Docket Number:	14-AAER-02
Project Title:	Computer, Computer Monitors, and Electronic Displays
TN #:	211614
Document Title:	California Investor Owned Utilities Comments: Computers - Response to Final Staff Report
Description:	N/A
Filer:	System
Organization:	California Investor Owned Utilities
Submitter Role:	Public
Submission Date:	5/23/2016 4:35:26 PM
Docketed Date:	5/23/2016

California Investor Owned Utilities Comments: Computers - Response to Final Staff Report

Response to Final Draft CEC Staff Report,
Revised Analysis for **Computers**

Docket #14-AAER-2

Figure 1: Desktop system compliance and modeled TEC improvements.

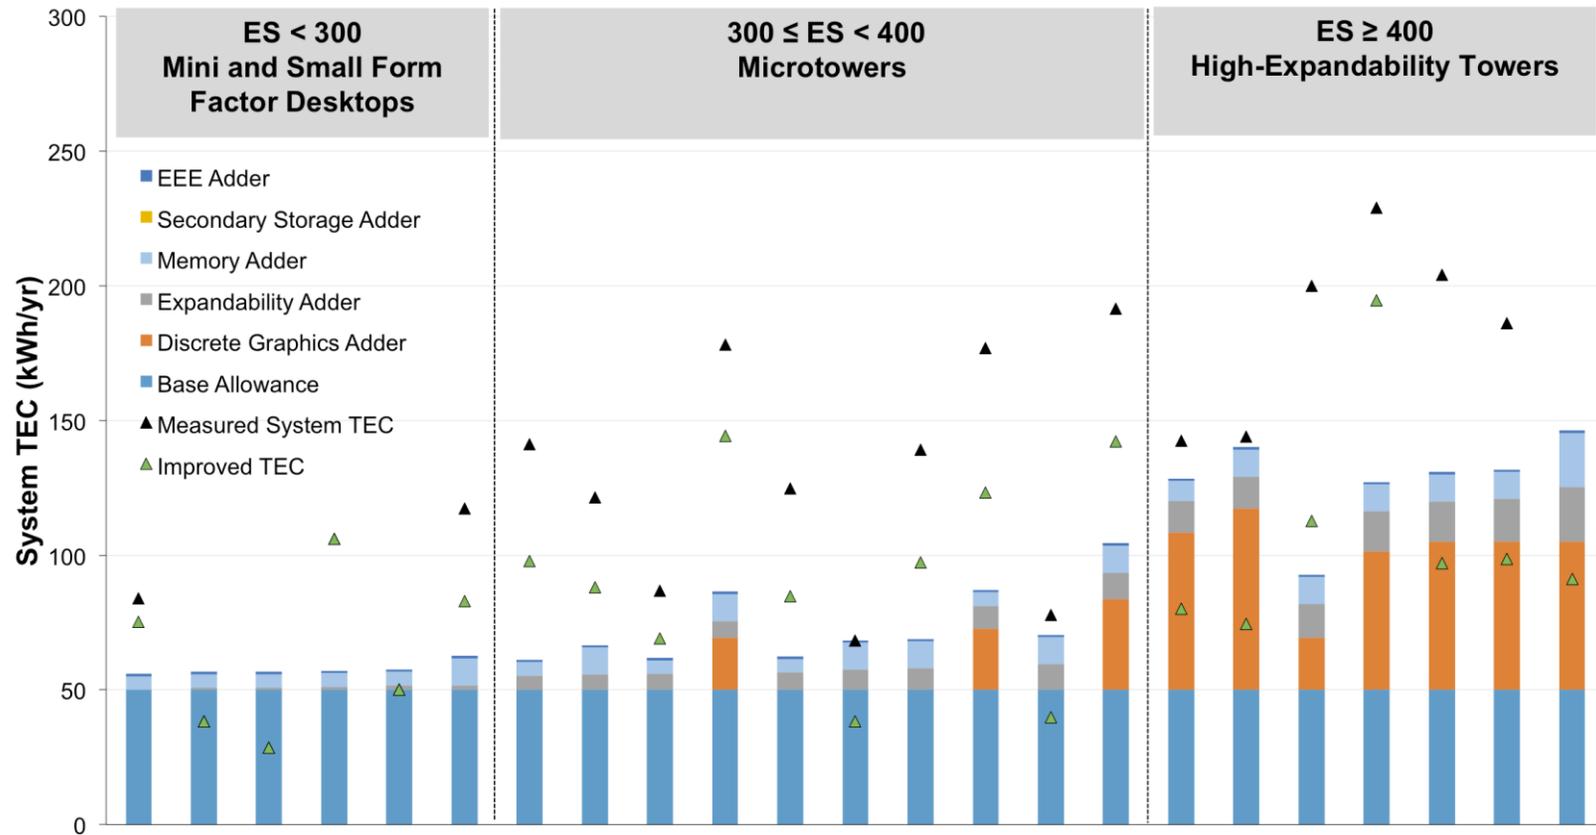
Six of the 23 systems would meet or be within 10% of meeting CEC’s Draft 2 proposal. A total of 10 of the 23 systems investigated would be able to meet Draft 2 levels today with the modeled TEC improvements. Thus, using existing, low-cost efficiency measures, over 40% of our desktop dataset would meet CEC’s Draft 2 proposal across a broad range of form factors and performance levels.

Figure 3: System categories based on PSU size and simplified expandability score

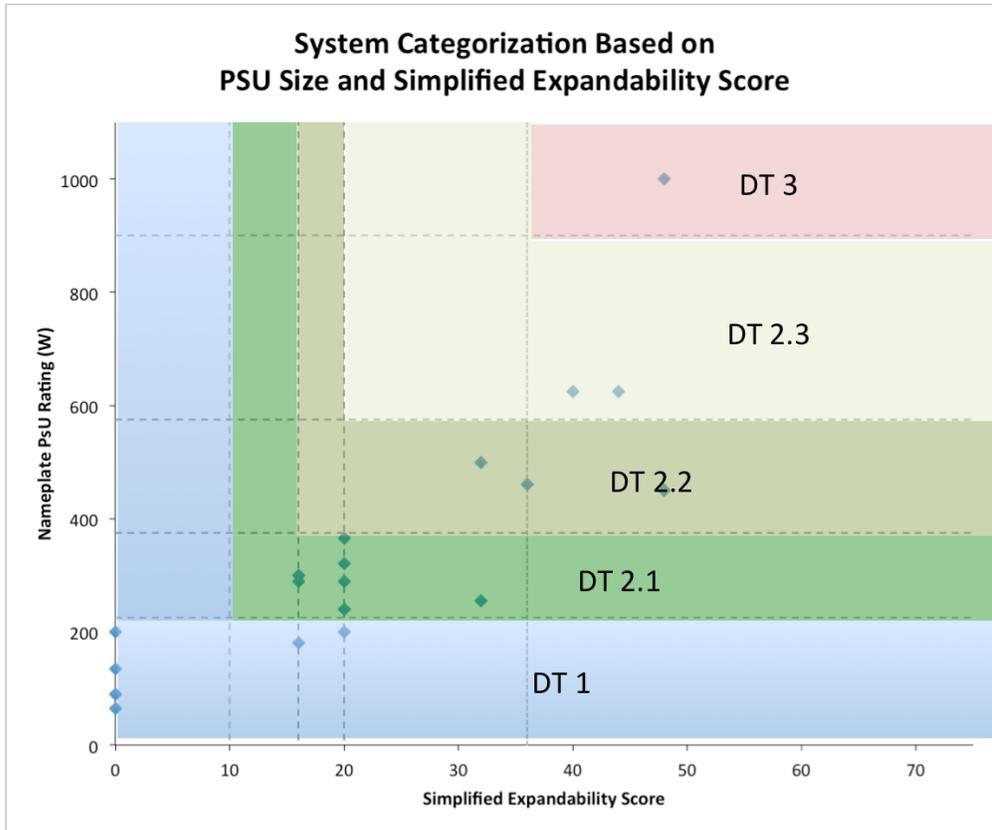
Table 1 provides the combined criteria for each category based on both PSU size ranges as well as simplified expandability score. Systems must meet both PSU and SES criteria to qualify for a category and its TEC allowance. The TEC allowances proposed are roughly equivalent to Draft 2 levels. Figure 3 illustrates how current systems in our dataset would be assigned to these categories based on a combination of their power supply size and their simplified expandability score.

Figure 4: Integrated desktop display adders

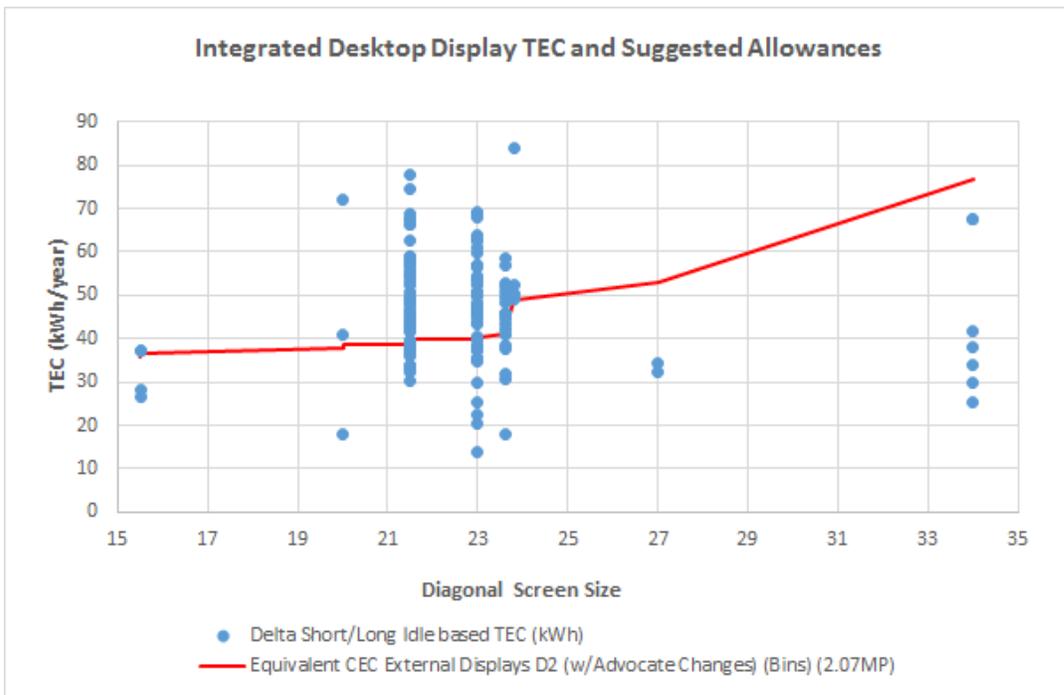
The chart above shows the suggested TEC display allowances (red line) for integrated desktop computers alongside TEC values calculated from the short and long idle deltas of integrated desktop computers in the ENERGY STAR database (limited to products with resolutions of 2.07MP to facilitate easier comparison between the measured TEC and allowance values).

For integrated desktop adders, we propose to align with the levels and size bins in CEC's standalone displays proposal, with an extra bin above 29 inches, consistent with our comments on displays.

Figure 5: Notebook display adders

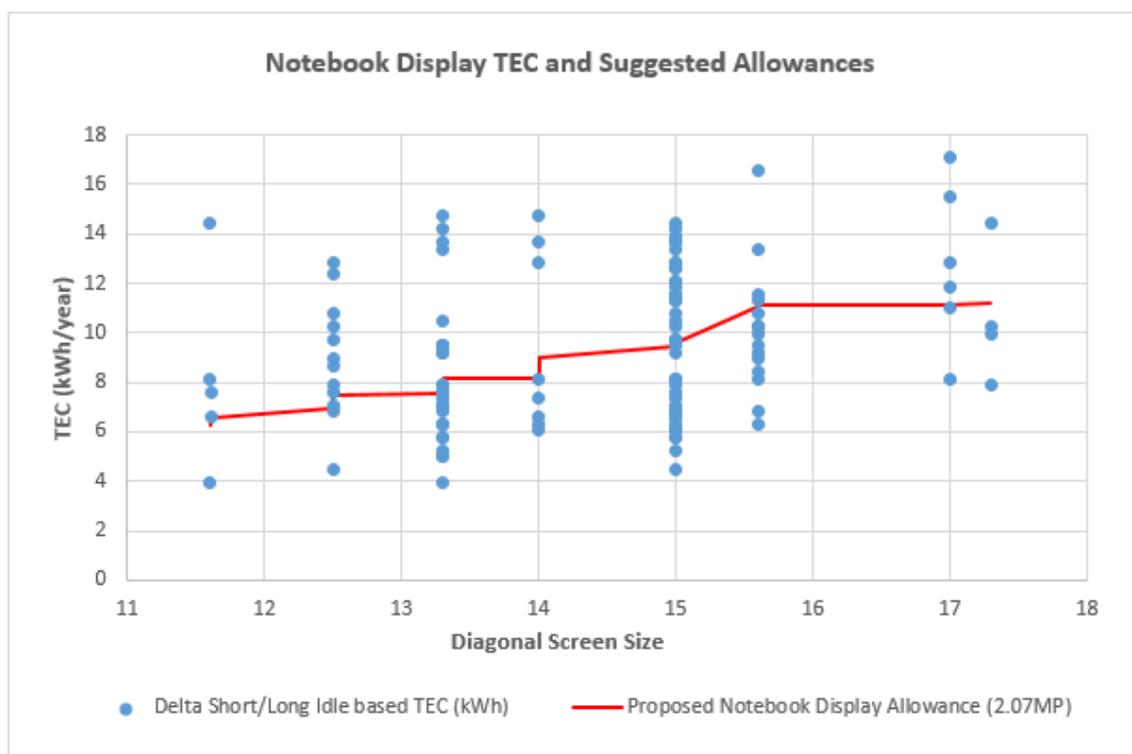
The chart above shows the suggested TEC display allowances (red line) for notebook computers alongside TEC values calculated from the short and long idle deltas of notebook computers in the ENERGY STAR database (limited to products with resolutions of 2.07MP to facilitate easier comparison between the measured TEC and allowance values).

For notebook adders, we propose to reduce adders to achieve a roughly 50% pass-rate relative to the ENERGY STAR 6.1 database, and to limit resolution to 5MP consistently with integrated display adders.

Figure 6: TEC Impacts of Secondary Storage Under a Variety of Power Management Scenarios

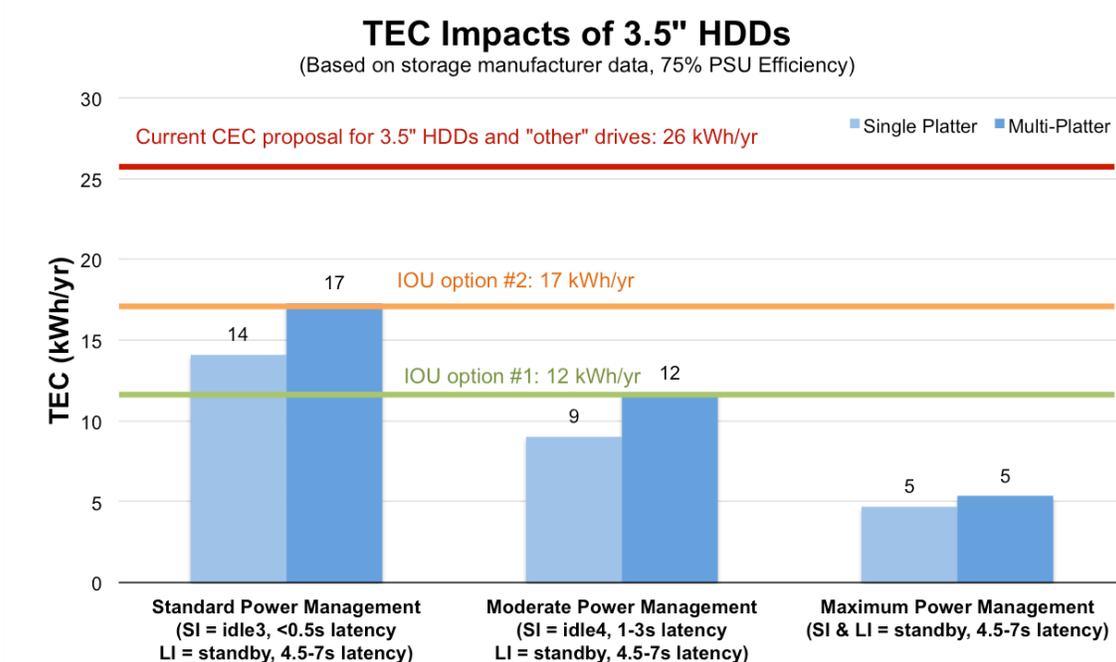
In meetings conducted since CEC's 2015 stakeholder workshop, industry storage manufacturers have noted several low-latency device power management states that could be used to reduce the energy impacts of secondary (and primary) drives with minimal latency impacts to the user. As depicted in Figure 4, we have utilized docketed hard drive power data to model TEC impacts of 3.5" hard drives under three power management scenarios with increasing power savings and latency impacts.⁵ Under all scenarios, we assume that the HDD is placed into standby (spun down) during long idle mode. Under scenario 1 ("standard power management"), we assume that the disk incorporates "idle" timers that allow it to enter a reduced speed, low-power state within the first 5 minutes of user activity (in alignment with proposed addenda to the ENERGY STAR test procedure), meaning it would be applicable to short idle mode under ENERGY STAR testing and real-world conditions. Scenario 2 ("moderate power management") assumes further motor speed reductions in short idle.⁶ Scenario 1 results in TEC impacts of 14-17 kWh/yr and latencies of less than 0.5s in short idle, whereas scenario 2 yields TECs of 9-12 kWh/yr and latencies of 1-3s. Under scenario 3 ("maximum power management"), the drive is spun down in short and long idle, yielding TECs of about 5 kWh/yr and latencies of 4.5-7s.

The CASE team proposes that CEC lower its secondary storage adder to 12 kWh/yr for 3.5” drives. This would provide enough allowance for even multi-platter drives under moderate power management (i.e. parking drive heads and reducing motor speeds). According to the aforementioned industry-docketed presentation, this type of power management is achievable today and incurs minimal latency (1-3s).

Figure 7: Demand reduction as a result of Auto-brightness control

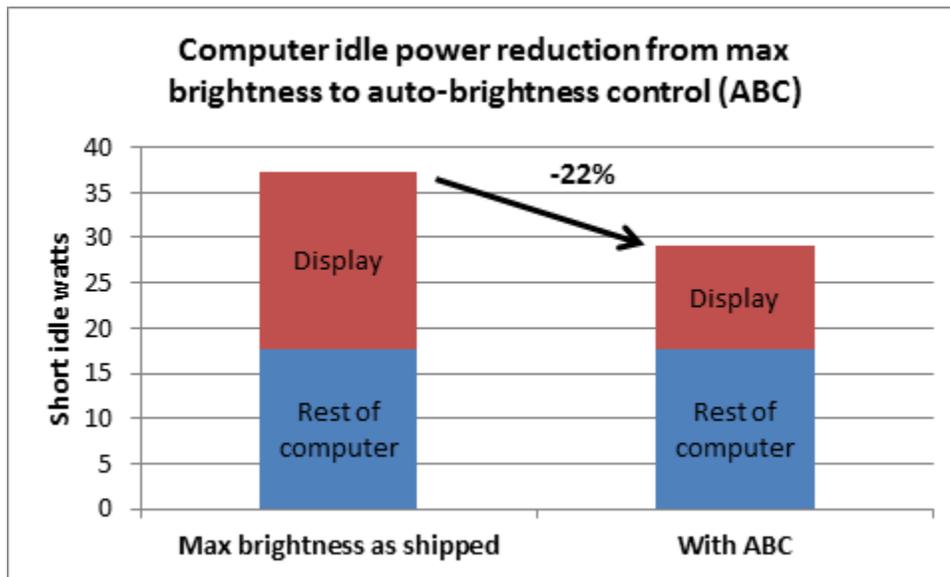
This method is not representative of real-world energy use, and it does not incentivize manufacturers to optimize display brightness settings on their computers. In fact, testing of two sample all-in-one computers showed one was shipped with maximum brightness, when the other used auto-brightness control (ABC).⁷ Enabling ABC on the first computer reduced the computer total idle power draw by 22% as shown in Figure 5. This is a large energy saving opportunity which costs nothing.

If ABC is enabled as shipped, keep it enabled and test with a light source so that 300 lux directly enter the ABC sensor.

If the display is shipped at a fixed brightness that is at least 90 cd/m² for notebook computers, and 150 cd/m² for integrated desktop computers, test with display brightness as shipped.

If the display is shipped at a fixed brightness that is less than 90 cd/m² for notebook computers and 150 cd/m² for integrated desktop computers, set the display to 90 cd/m² for notebook computers and 150 cd/m² for integrated desktop computers. If the unit under test (UUT)'s brightest setting cannot achieve the specified brightness, then set the UUT display to the brightest setting" (per ENERGY STAR).
